ATTACHMENT A

EXISTING TECHNICAL SPECIFICATIONS AND BASES
UNIT 2

ATTACHMENT B

PROPOSED TECHNICAL SPECIFICATIONS AND BASES
UNIT 2

FIGURE 3.4-2

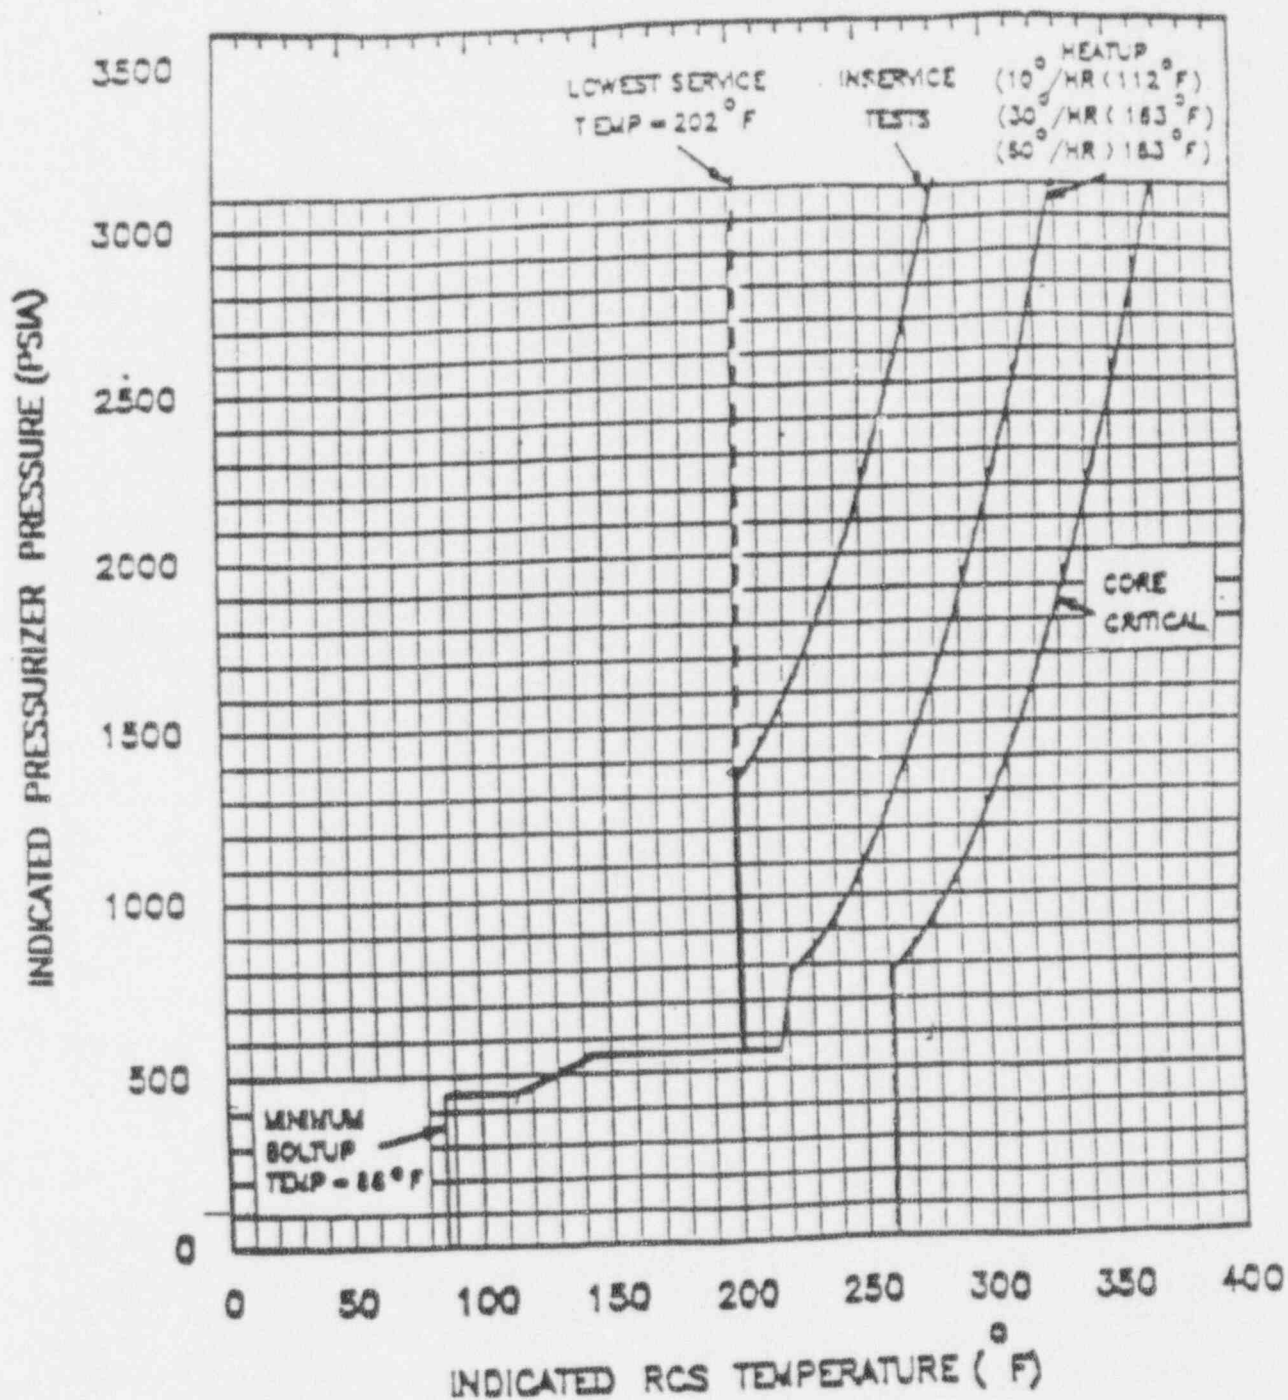
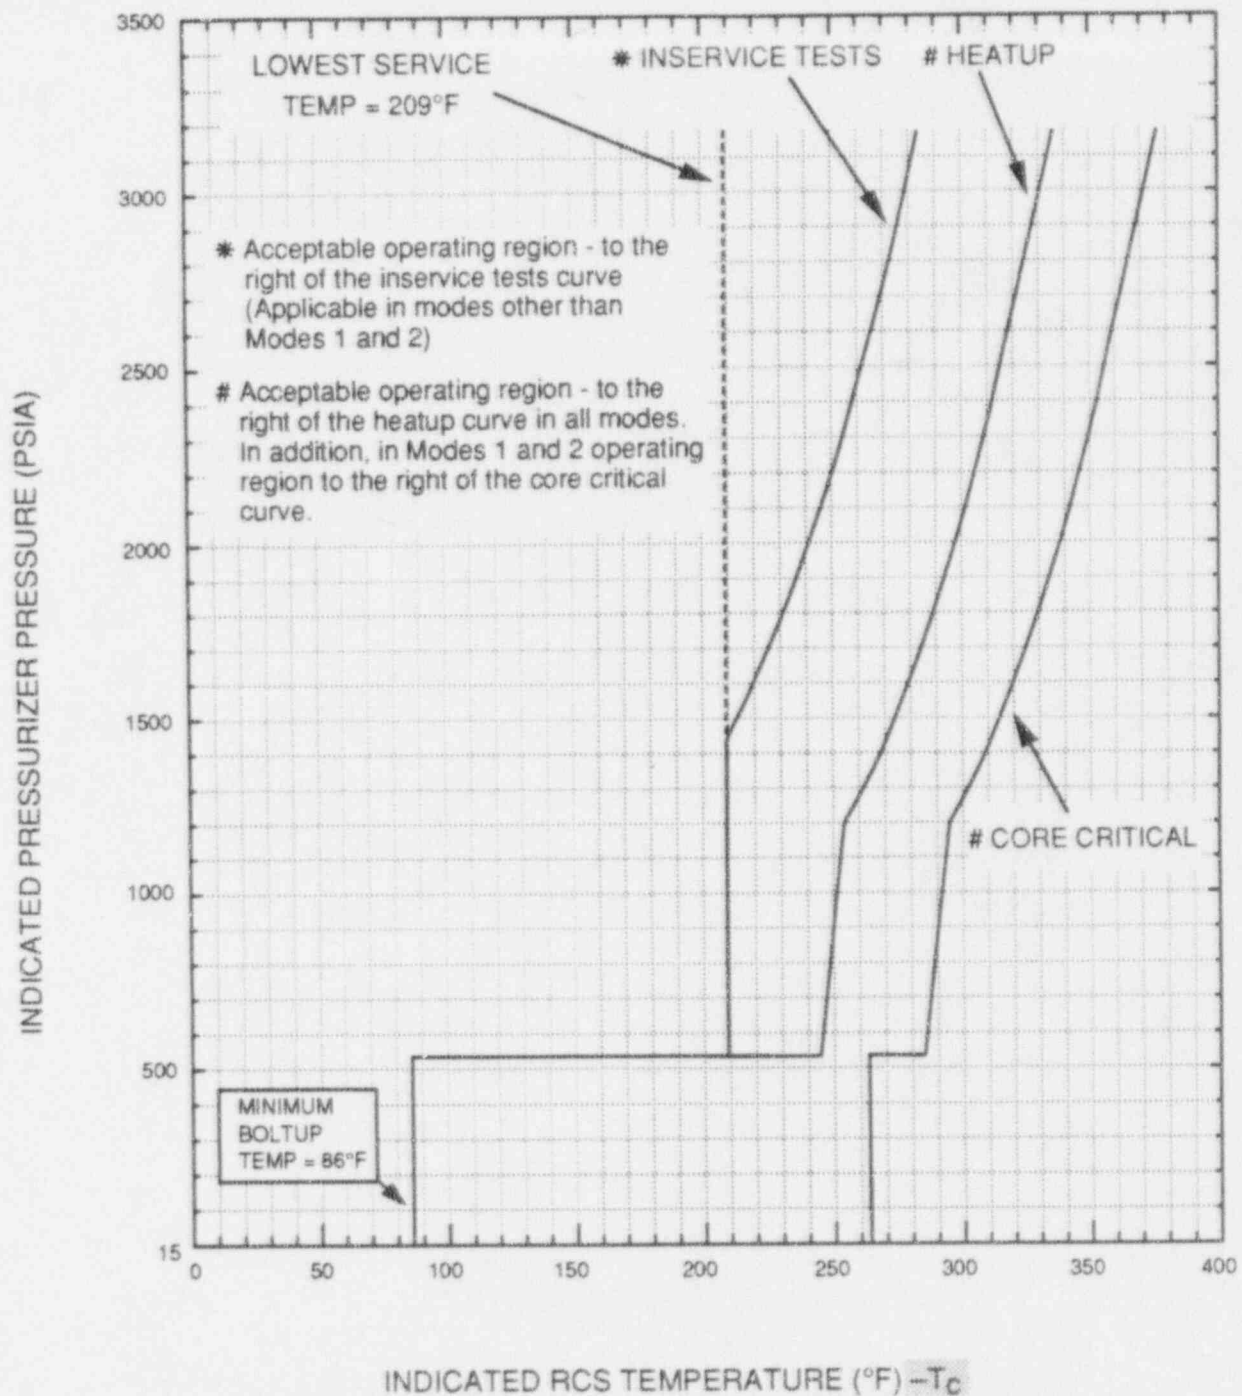
3.4.8.1 With the reactor vessel head bolts tensioned*, the Reactor Coolant System (except the pressurizer) temperature and pressure shall be limited in accordance with the limit lines shown on Figures 3.4-2, and Figure 3.4-3, 3.4-4, 3.4-5, 3.4-6, and 3.4-7 during heatup, cooldown, criticality, ~~heatup~~, and inservice leak and hydrostatic testing with:

SONGS 2 HEATUP RCS PRESSURE/TEMPERATURE
LIMITATIONS FOR 4— UNTIL 8 EFPY
Normal Operation

The heatup and cooldown limit curves for normal operation (Figures 3.4-2 and 3.4-3 3.4-4) and the cooldown limit curve for remote shutdown operation (Figure 3.4-6) are composite curves which were prepared by determining the most conservative case, with either the inside or outside wall controlling, for any heatup rate of up to 60°F/hr or cooldown rate of up to 100°F/hr. The limit curves for Remote Shutdown operation are determined using the Total Loop Uncertainties (TLUs) for temperature and pressure for the Remote Shutdown Panel instruments in which the pressure TLUs are higher than those for the Control Room shutdown instruments. The heatup and cooldown curves were prepared based upon the most limiting value of the predicted adjusted reference temperature at the end of the service period, and they include adjustments for ~~possible errors in the pressure and temperature sensing instruments~~ instrument uncertainties, and static and dynamic heads.

FIGURE 3.4-3 3.4-4

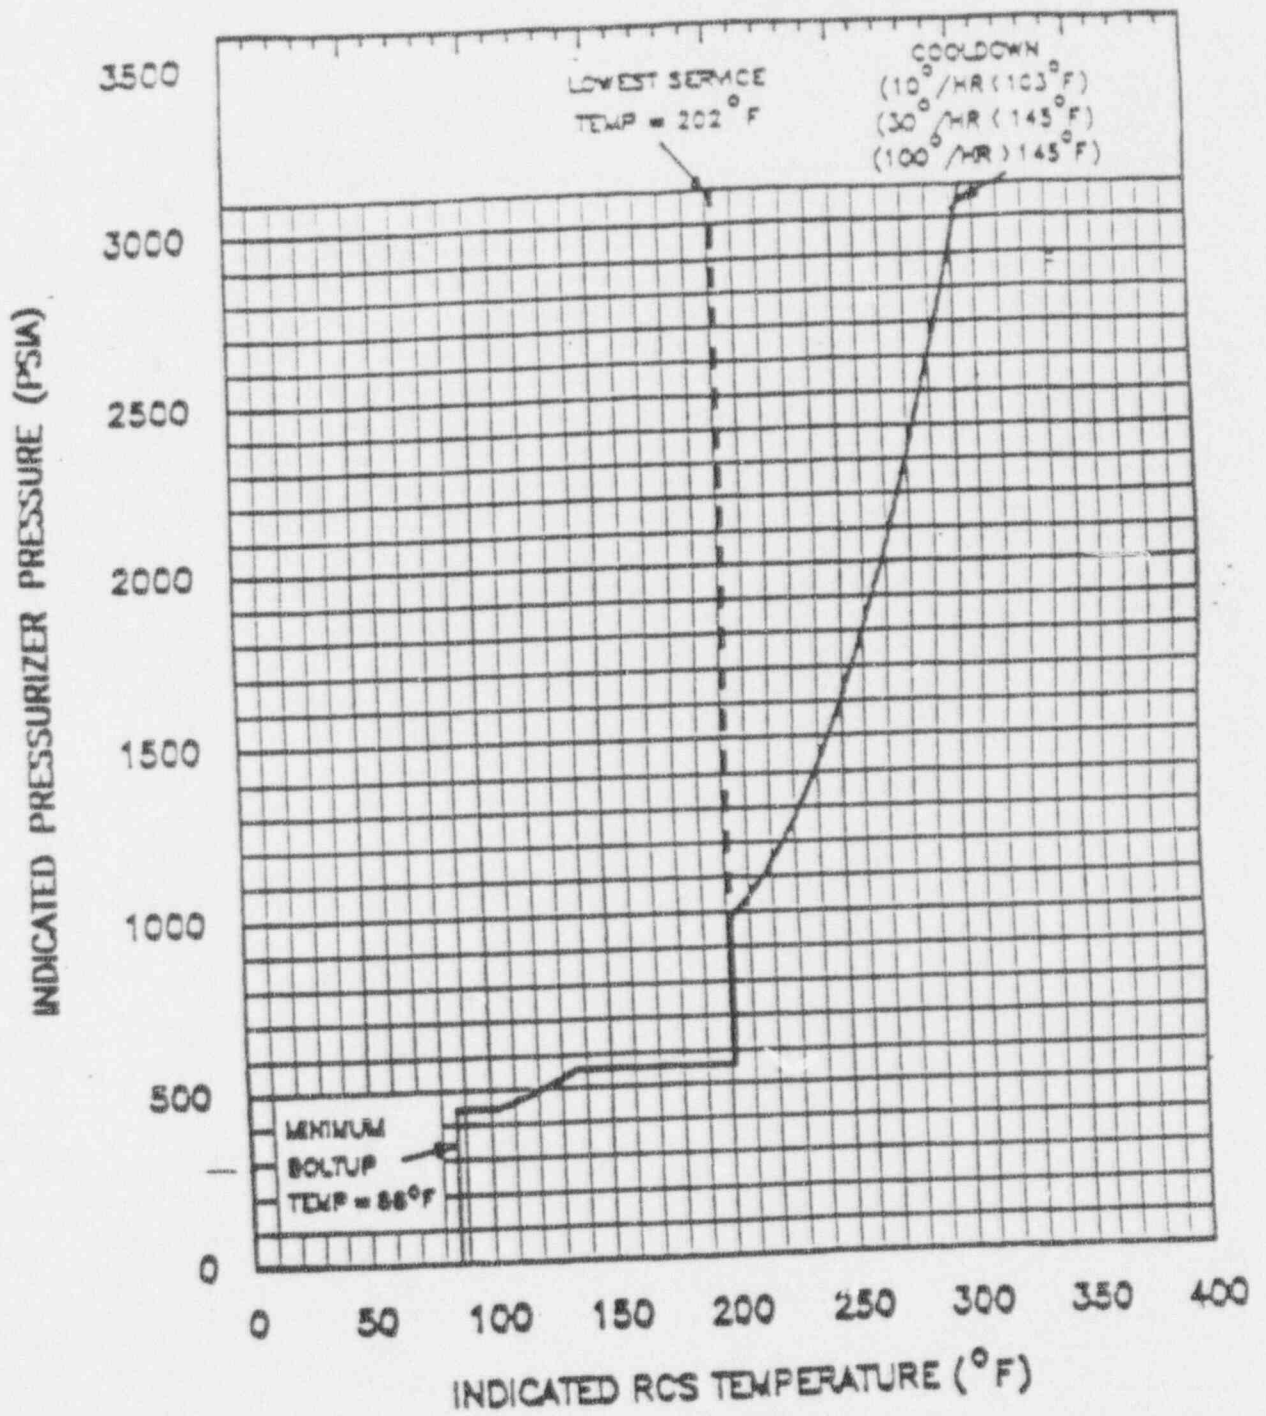
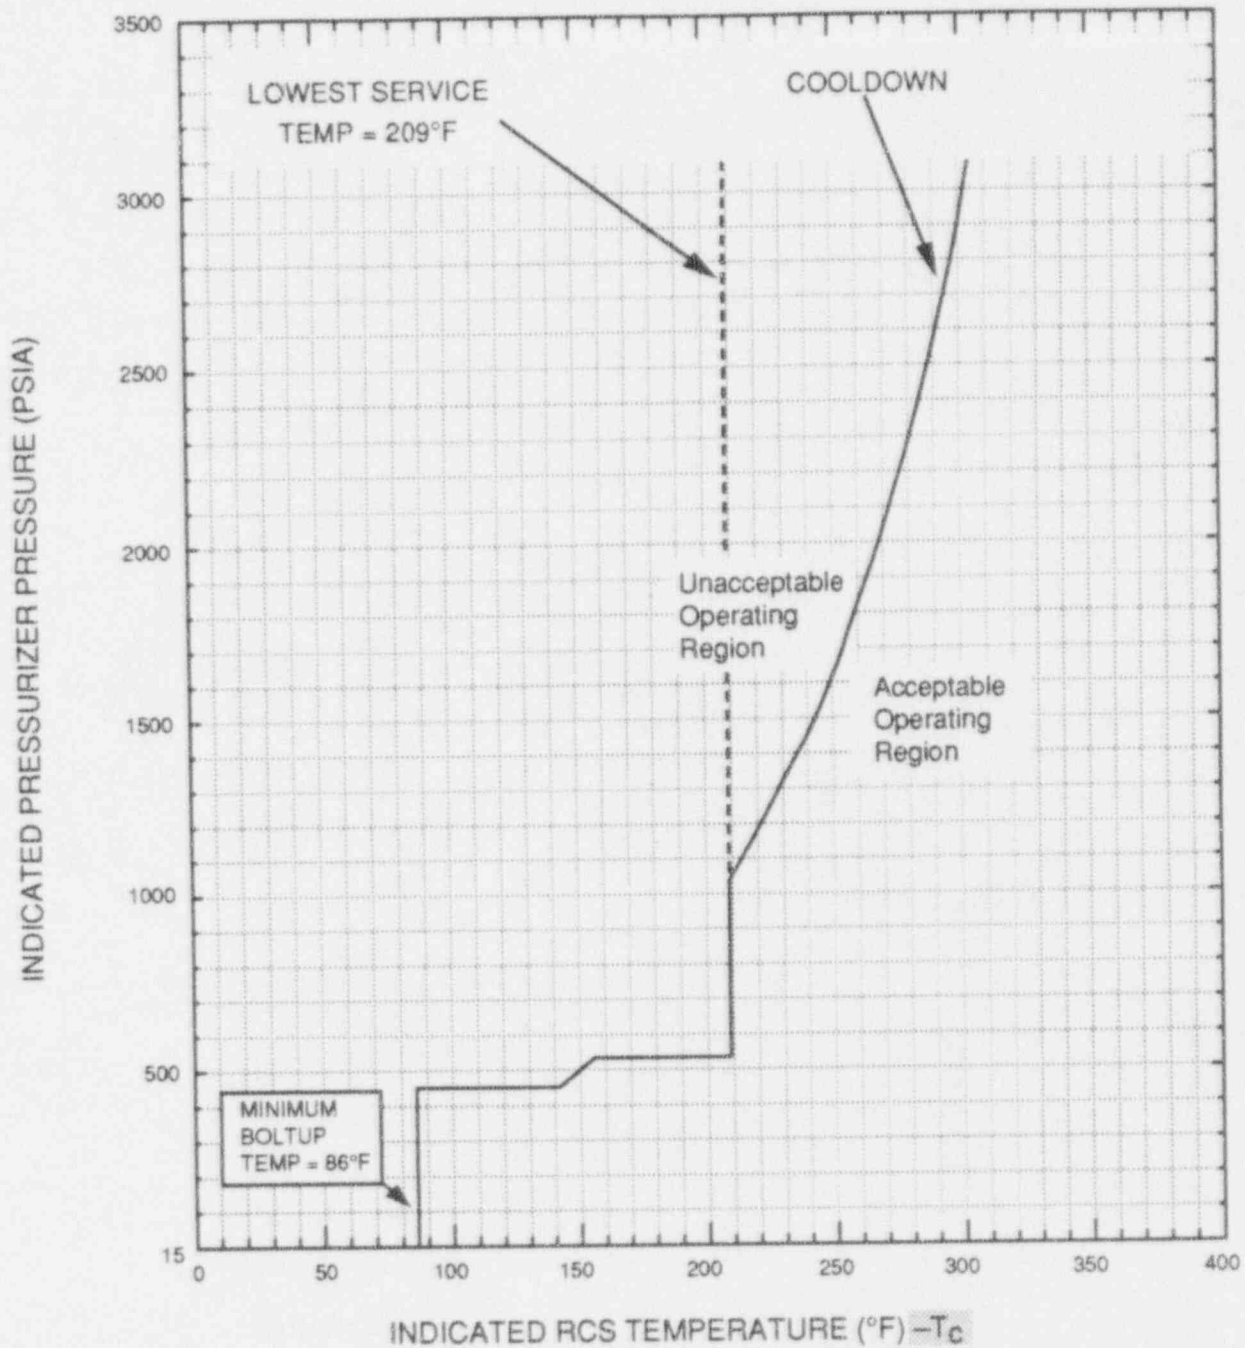
(Figure 3.4-3 - Not Used)

SONGS 2 COOLDOWN RCS PRESSURE/TEMPERATURE
LIMITATIONS FOR 4 UNTIL 8 EFY
Normal Operation

FIGURE 3.4-5

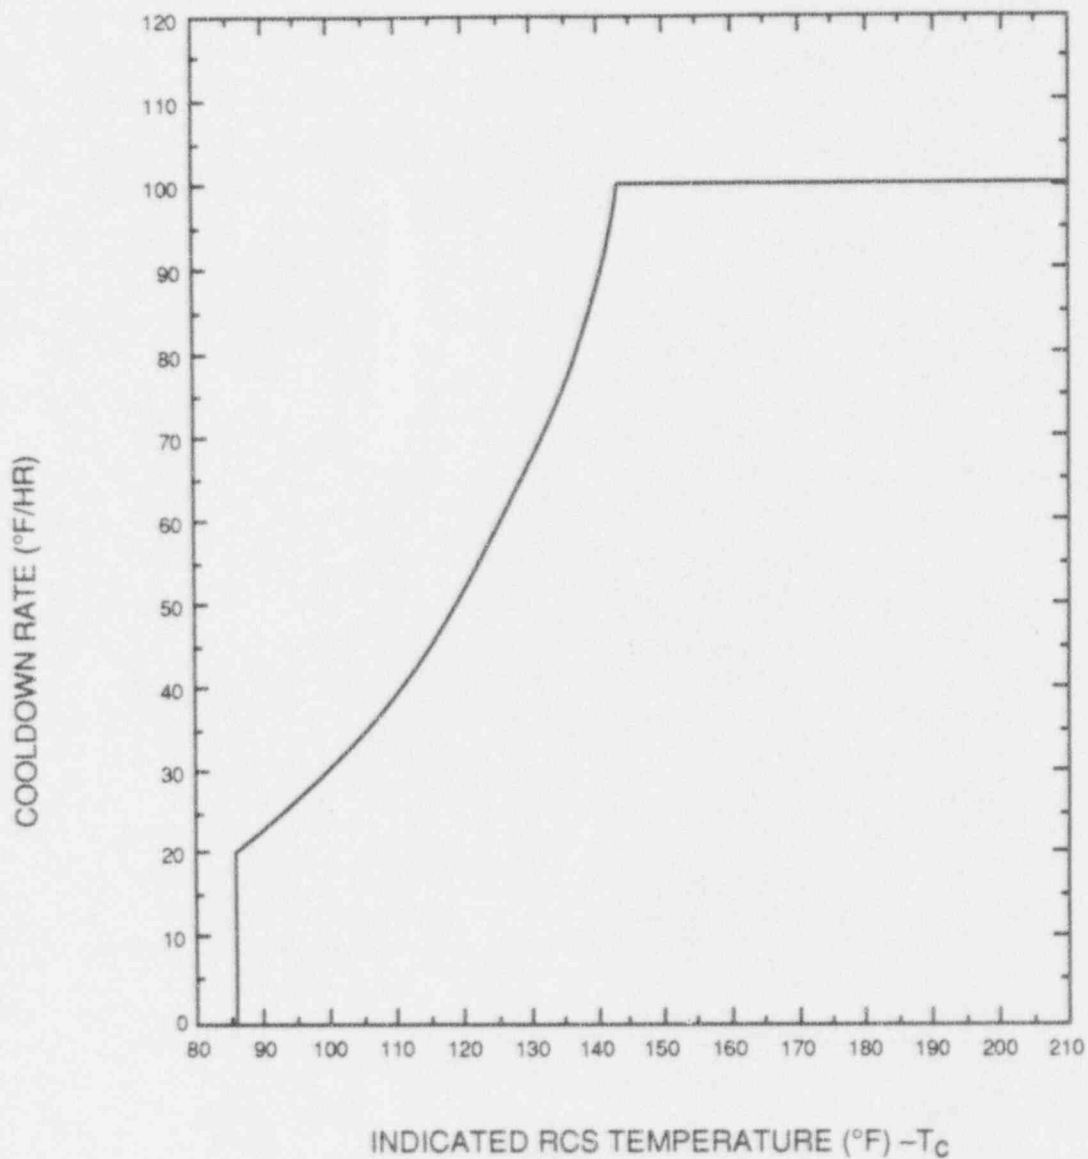
NOTE: A MAXIMUM COOLDOWN RATE OF 100°F/HR IS ALLOWED
AT ANY TEMPERATURE ABOVE 143°F

SONGS 2 RCS PRESSURE/TEMPERATURE LIMITS
MAXIMUM ALLOWABLE COOLDOWN RATES (UNTIL 8 EFY)
Normal Operation

- b. ~~A maximum cooldown of 10°F in any one hour period with RC cold leg temperatures less than 103°F. A maximum cooldown of 30°F as specified by Figure 3.4-5 in any one 1-hour period with RCS cold leg temperature less than 145 or equal to 143 °F. A maximum cooldown of 100°F in any one 1-hour period with RCS cold leg temperature greater than 145 143 °F.~~

FIGURE 3.4-6

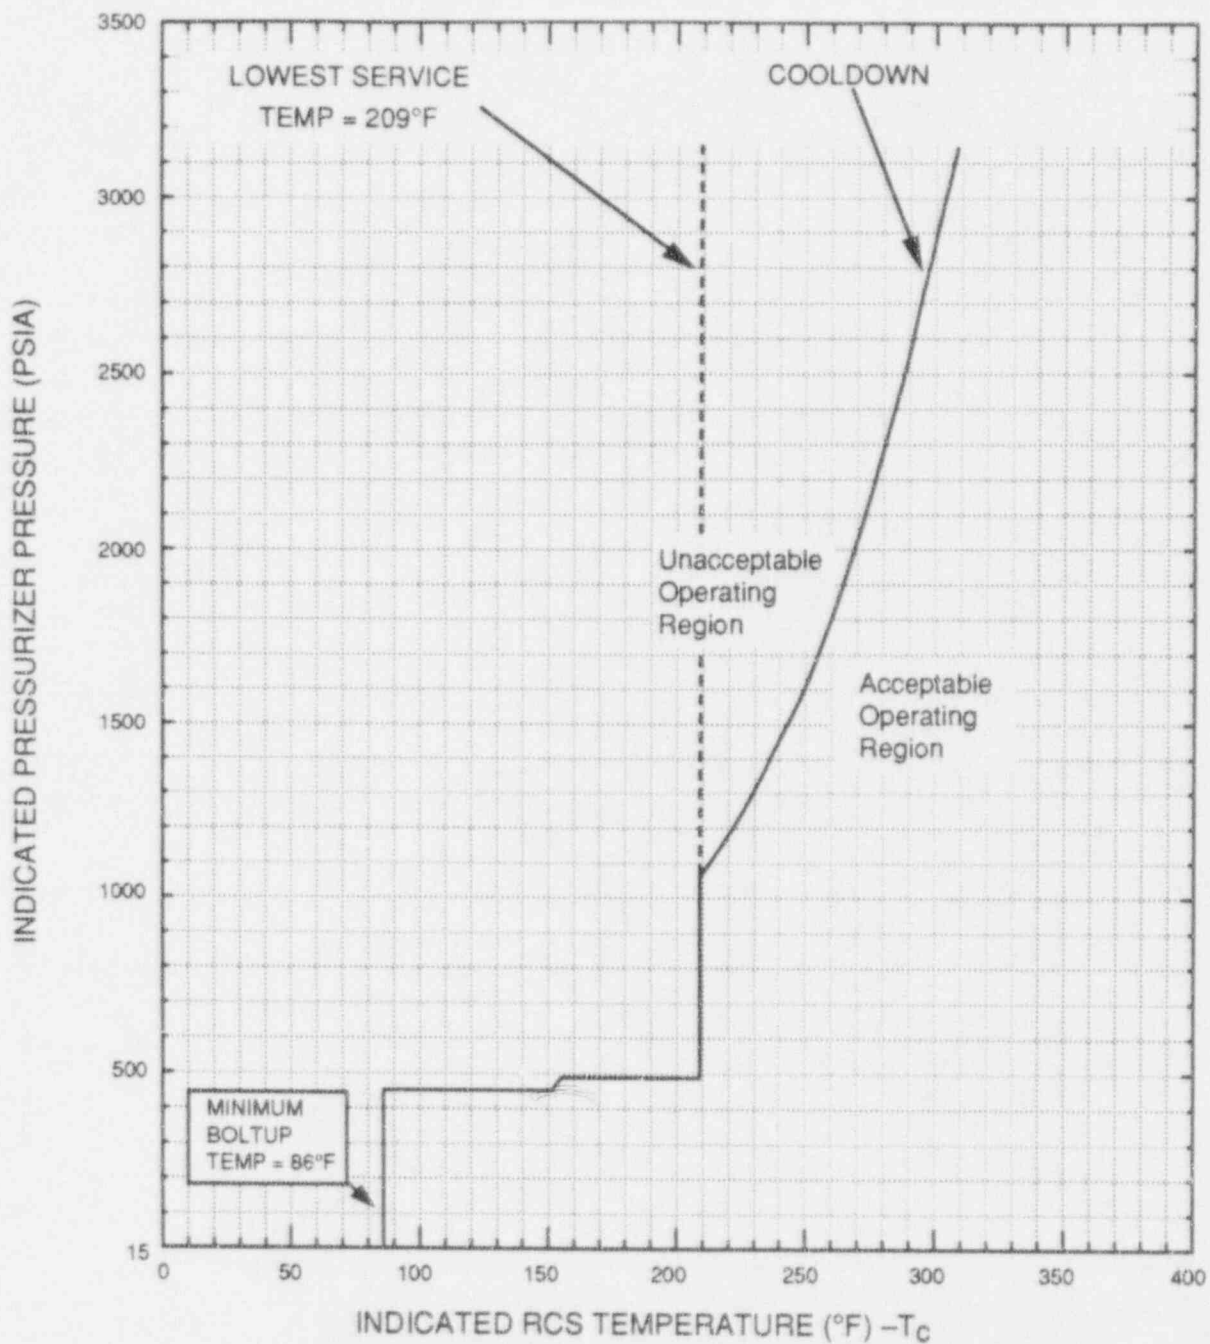
SONGS 2 COOLDOWN RCS PRESSURE/TEMPERATURE
LIMITATIONS UNTIL 8 EFPY
Remote Shutdown Operation
